# Gardens of Peace Muslim Cemetery

## Written Representation

Deadline 2

## Appendix 4.0 – Plot 1/8 Overlay

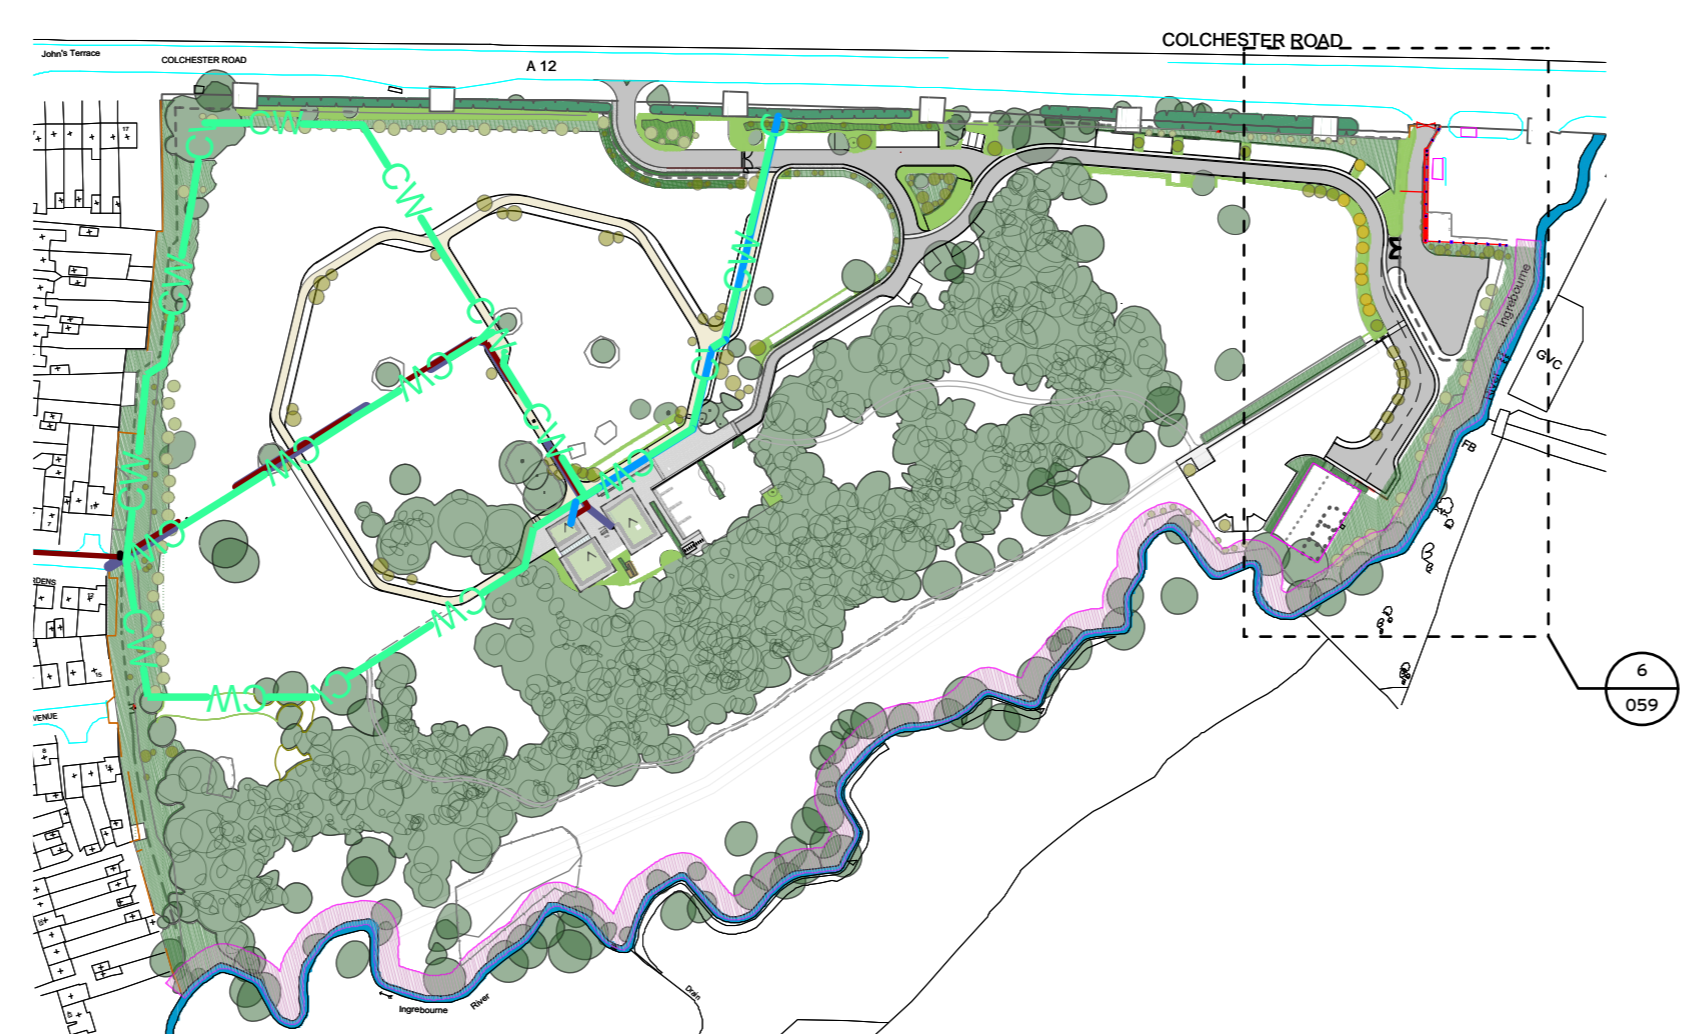
- a. Temporary loss of internal road network (as evident within appendix 4)
- b. Temporary closure of service entrance (off Colchester Road into Maylands) (as evident within appendix 4)
- c. Temporary loss of half of the cemetery's overflow car park (shaded light green in Appendix 4)
- d. Temporary loss of the soil storage area (as evident within appendix 4)
- e. Temporary loss of access to maintenance building and store
- f. Permanent loss of 512 burial plots (as evident within appendix 4)

As you will note within Appendix 1 and Appendix 4, Maylands is to have two entrances off Colchester Road (A12), one dedicated entrance for public / mourners and a separate entrance for all service vehicles only. This is to ensure the safety of visitors and staff by minimising overlaps between the operations and movements in each user group. Furthermore, having two entrances ensures a clear separation of all service and maintenance traffic from the sensitive occasion of congregations.

The approved design for the cemetery incorporates public and coach parking throughout the site, with an area designated as overflow parking (large area shaded yellow within Appendix 1 and shaded light green in Appendix 4).

We draw your attention to Appendix 4. A further consequence of the Scheme to the development of Maylands is the severance of the workshop / store. The road providing access to the workshop / store, being the same road which links to the service entrance, falls within Plot 1/8.
